Addendum No. 2
BL049-24
Wolf Lake (Y-14) Dam Rehabilitation

The following addition/changes modify the Bid No. BL049-24 "Wolf Lake (Y-14) Dam Rehabilitation Contract Documents, dated April 2024, as first advertised on April 03, 2024.

EC-102

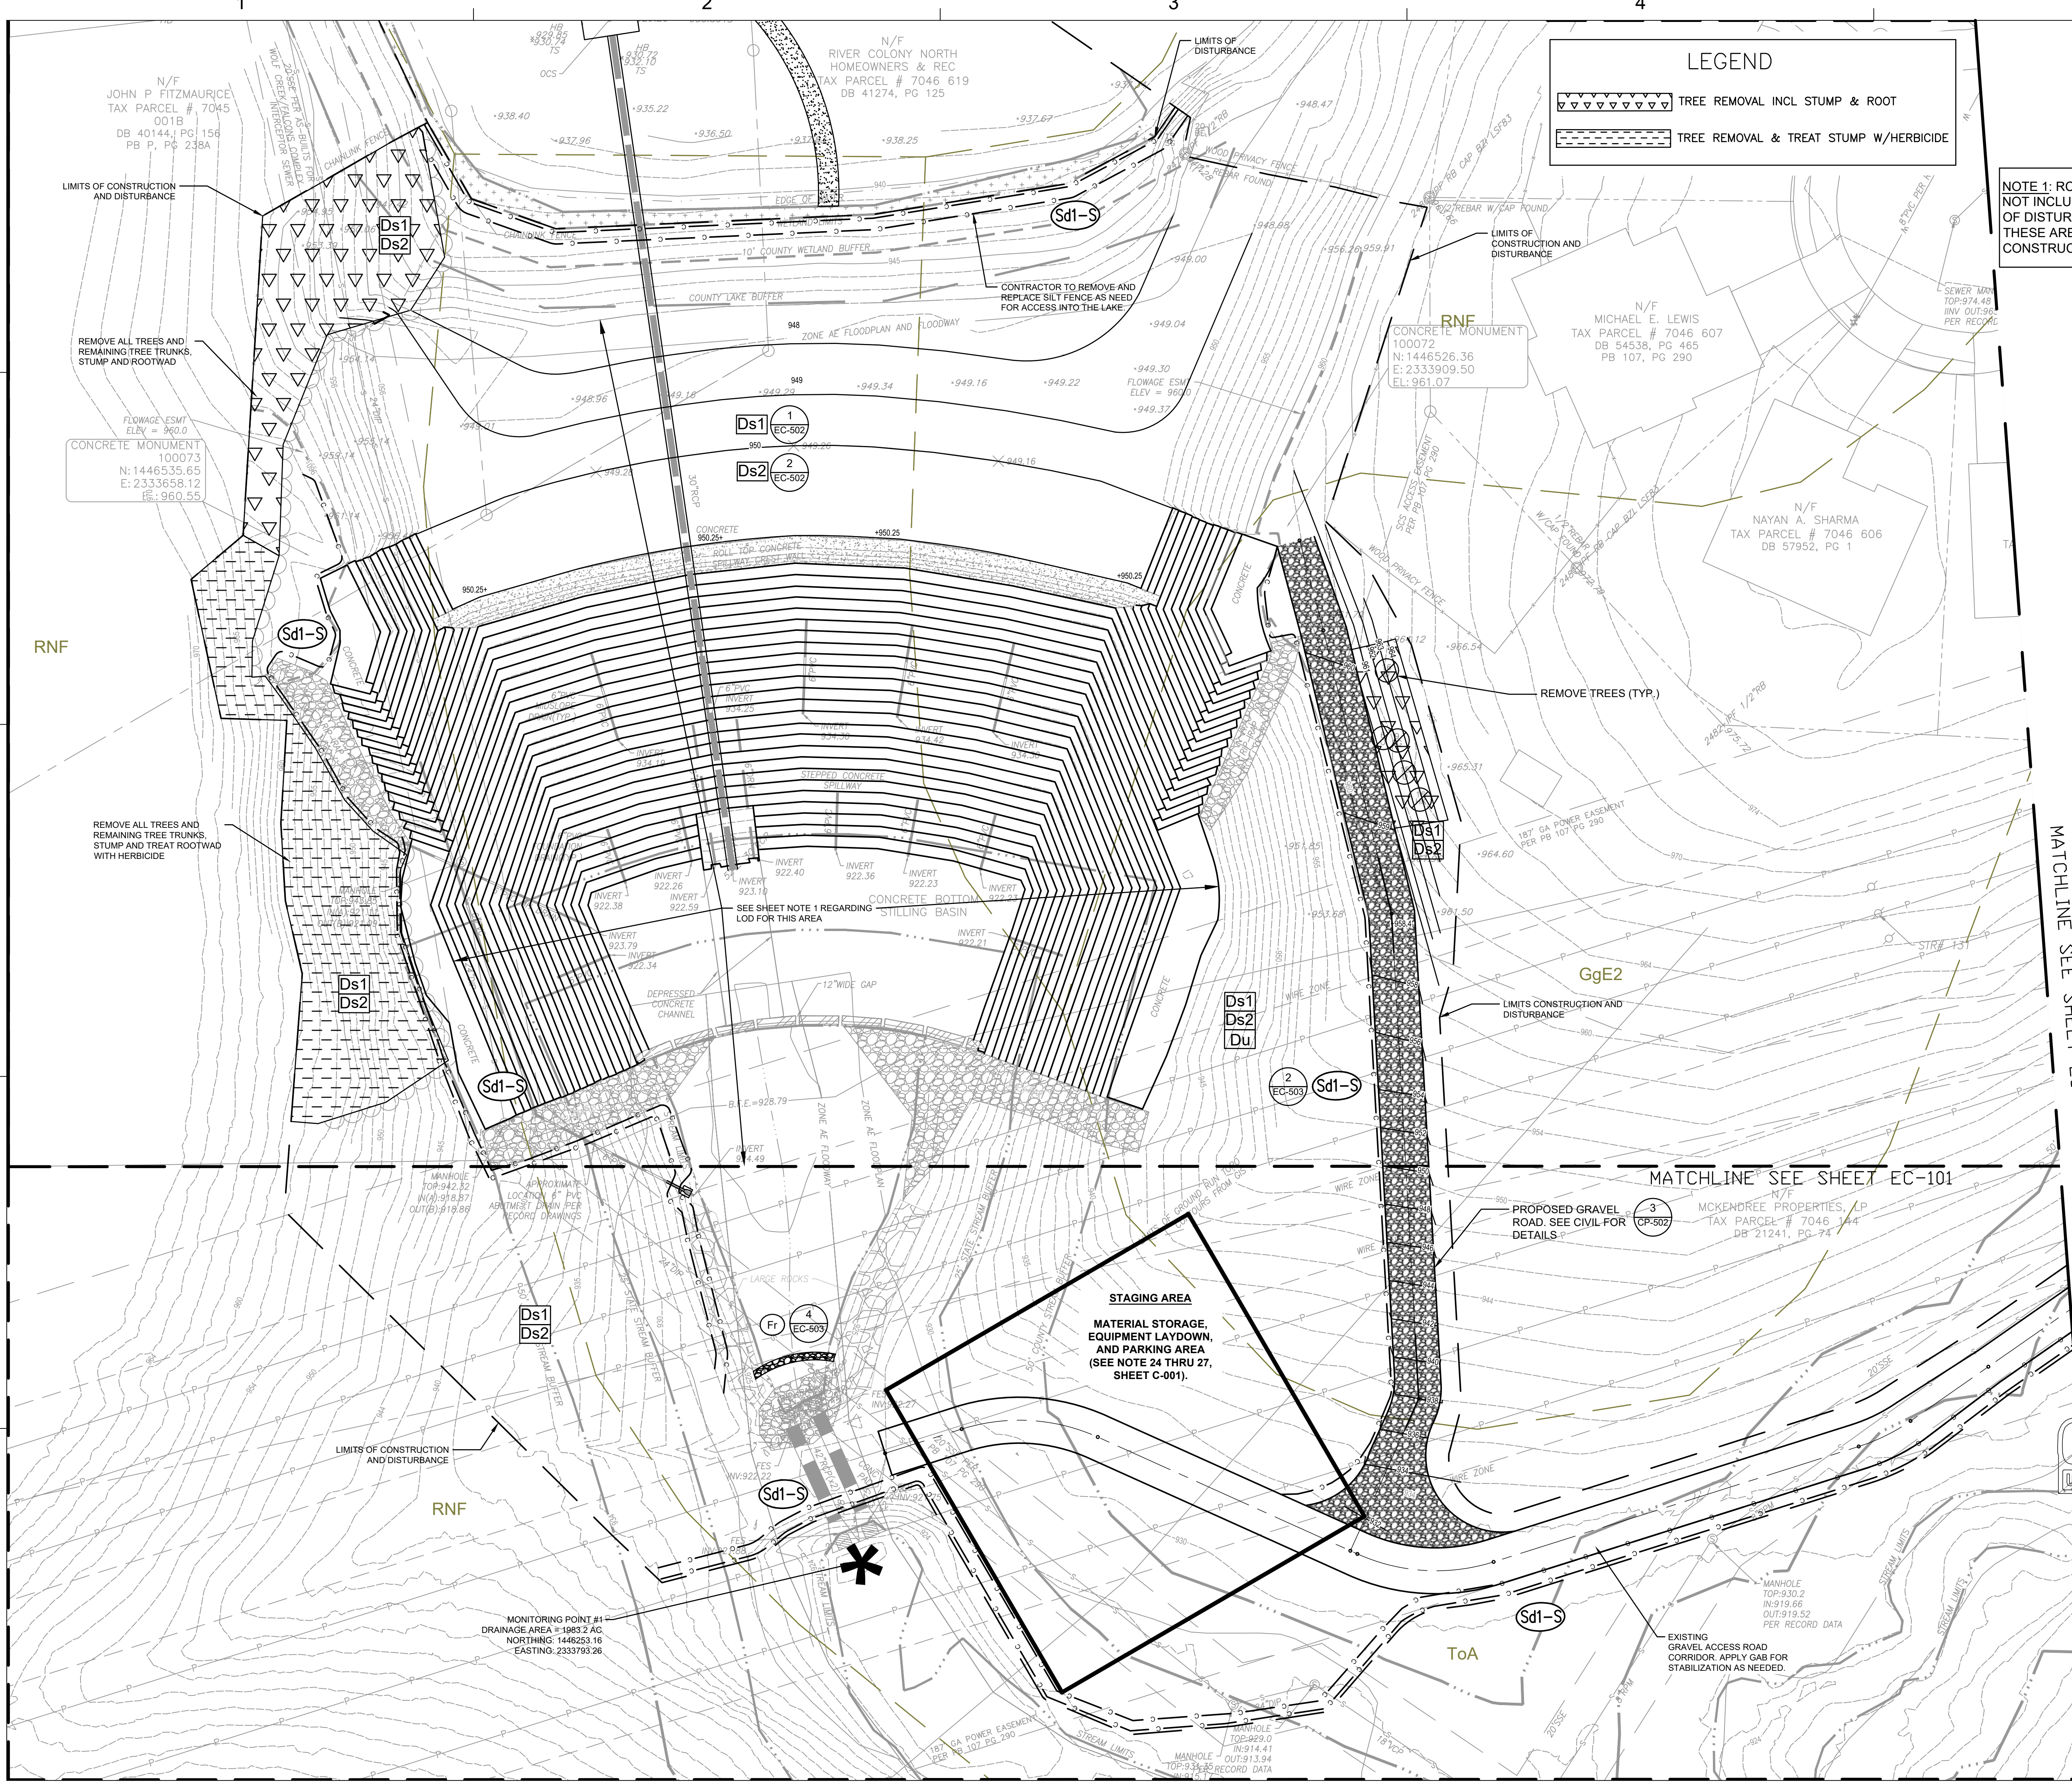
Q5. Drawings EC-101 and EC-102 show different symbols (triangles or dashes) around the site for Ds1 & Ds2 areas. Please clarify what the different symbols signify.

A5. A legend has been added to EC-101 and EC-102 to provide clarification.

- R2. Construction Plan Sheets EC-101 through EC-102:** Replace Sheets EC-101 through EC-102 dated 2/14/2024 in the Construction Plans with the attached revised Sheets EC-101 through EC-102 dated 5/9/2024. See A5.
